SAFETY ASSESSMENT GUIDELINES

October 2008

As the title suggests - **Safety Assessment (SA) Guidelines** - these Guidelines place considerable emphasis on expanding the RSA process beyond roadways. The SA Guidelines are designed for use on the local transportation system of New York State both by MPOs and local agencies. The Guidelines are based on conventional RSA principles as outlined in the FHWA RSA Guidelines, but tailor the process to the conditions experienced by NYSMPOs and local agencies throughout New York State. They emphasize a connection between the transportation planning process, multi-modal considerations, enforcement activities, safety education, and engineering solutions.

Figure 5 – Driveway B

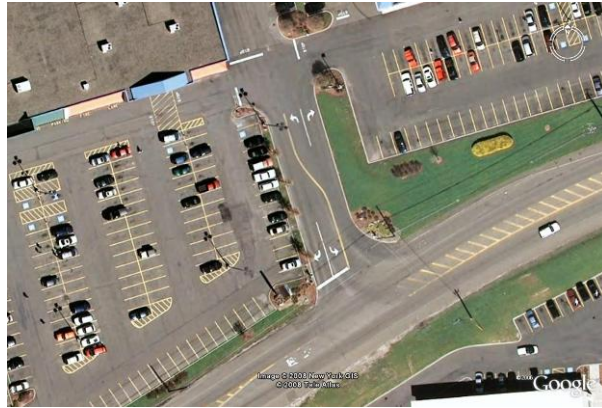
Driveway B serves both the Michaels/Old Navy Plaza and the Staples Plaza on the north side of CR 64, and is controlled by a STOP sign (**Figure 5**). The driveway is located on the outside of a horizontal curve in CR 64, and is skewed with respect to the CR 64 alignment. Collision experience at this location (16 in total) is dominated by angle collisions (12) involving westbound vehicles striking vehicles turning left out of the driveway.

Figure 8 – Driveways E and F

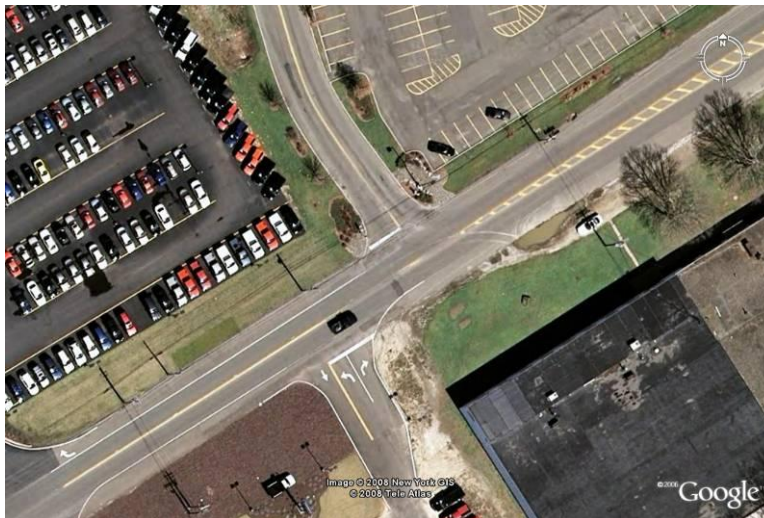
Driveway E extends to the north, and provides a second access to the Staples Plaza. **Driveway F** extends to the south and provides access to the Simmons Rockwell Auto Sales (**Figure 8**). The two driveways are offset from one-another and no left or right turn lanes are provided.

Figure 9 - Driveway G

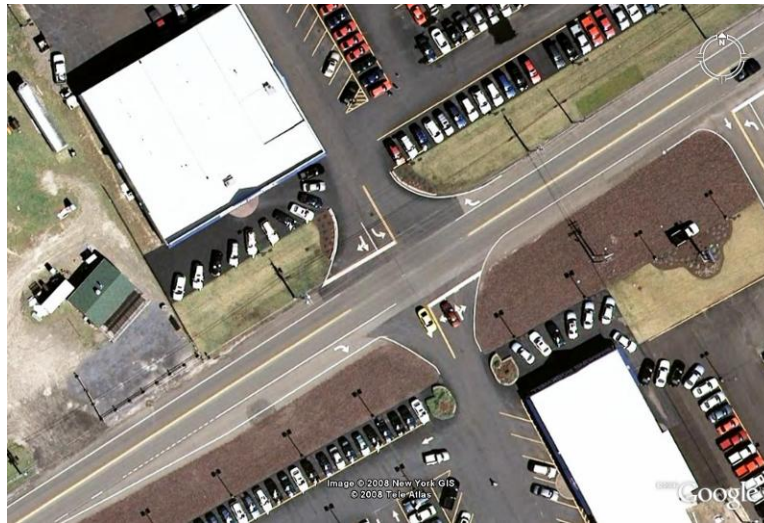
Driveway G to the north and south serves as the main driveway to Simmons Rockwell Auto Sales (**Figure 9**). A significant amount of pedestrian activity was noted as occurring between the north and south at this location. A westbound right turn arrow has been marked within the paved shoulder. Left turn lanes are not provided.

Figure 13 – Revised Entrance Scheme

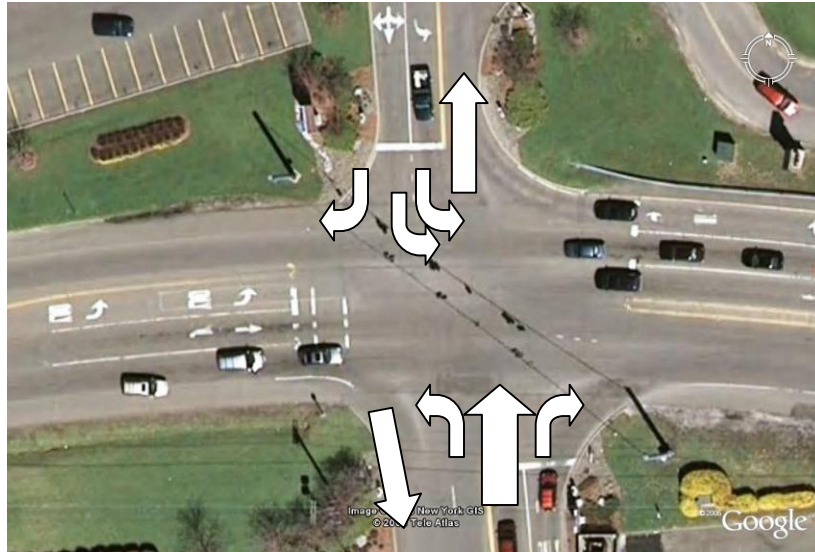
posing the risk of an opposing sideswipe collision (**Figure 12**). The outer southbound left turning vehicle is turning into the same away lane as a northbound right turning vehicle. Under permissive operation, the left turning vehicle must yield. However, given the unusual nature of the operation, this may not be evident to all users.

Suggestions: *Re-examine operational need for dual left turns. If required, consider:*

- *Split phasing northbound/southbound to separate conflicting movements in time; or*
- *Geometric revisions to southbound (two exclusive left turn lanes, one through-right turn lane, and one inbound lane) and/or southbound (one exclusive right turn lane, one through lane, one exclusive left turn lane, and one inbound lane) to offset the conflicting movements, with or without the introduction of exclusive left turn phasing.*

In the interim, consider refurbishing “chicken track” markings to delineate and de-conflict the opposing left turn movements.

Figure 2 – Ditch Back Slope and Utility Pole

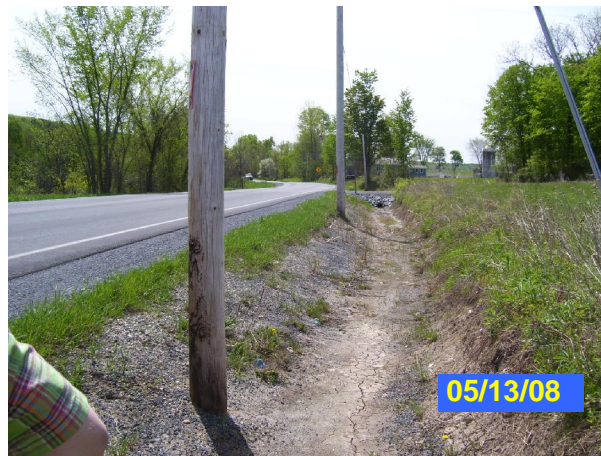
Observations: The ditch along the west side of CR 12 (adjacent to the southbound lane) has a near-vertical back slope approximately 200 to 300 yards north of Hatch Hill Road (southern junction). Utility poles are located within the foreslope (**Figure 2**).

Risk Analysis: A steep ditch back slope raises the potential for overturning an errant vehicle, resulting in a higher collision severity outcome. The collision data set contained information on one vehicle rollover associated with this location. This combination of ditch geometry and pole location risks errant vehicles being directed into a roadside fixed object collision.

Suggestions: *Re-grade ditch and flatten back slope to 1:3 or flatter. Explore opportunities to relocate poles on the outside of a horizontal curve behind the ditch and outside of the clear zone.*
